# Service Bulletin No. 22

Page 1 of 3  
Date: 1/26/04

**SUBJECT:** Wiring to Avionics Converter installed under right front seat

Interior Panel Locations -  
Right Side View From Inside

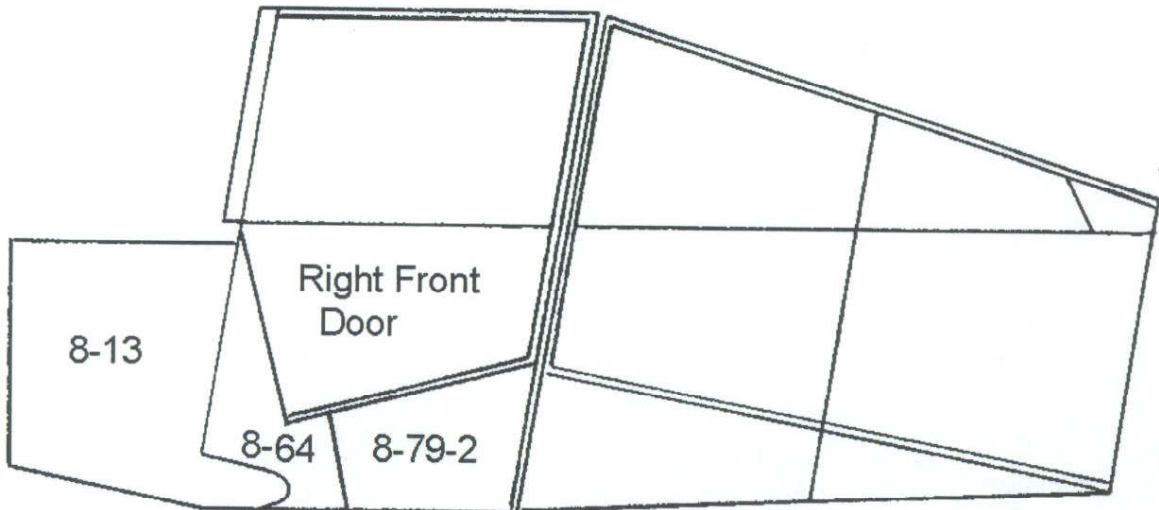
**BACKGROUND:** This Service Bulletin is prompted by a report received by Maule. Wiring down the right side of the airplane from instrument panel passes through interior panel to converter installed on floor under the seat. Wires were chaffed by interior panel against the step support tube. Insulation on the wires was abraded to bare wire which arced and burned small area of vinyl covered aluminum panel and structural tube.

3. Loosen forward kick panel (8-13) and remove panel (8-64) under forward door opening. Refer to accompanying sketch for locations. Remove panel (8-79-2) if necessary for inspection.

4. Inspect converter wiring where it passes through panels at step support tube. Look for evidence of cutting, abrasion, or arcing where wires pass through the panels adjacent to the step support tube.

5. Replace any damaged wiring and reroute the wiring if necessary to agree with Sketch #2, page 2. Enlarge the opening in the panel if necessary. Clean and repaint any area on the step support tube that suffered from arcing. Replace or repair the (8-64) and (8-79-2) panels if burned.
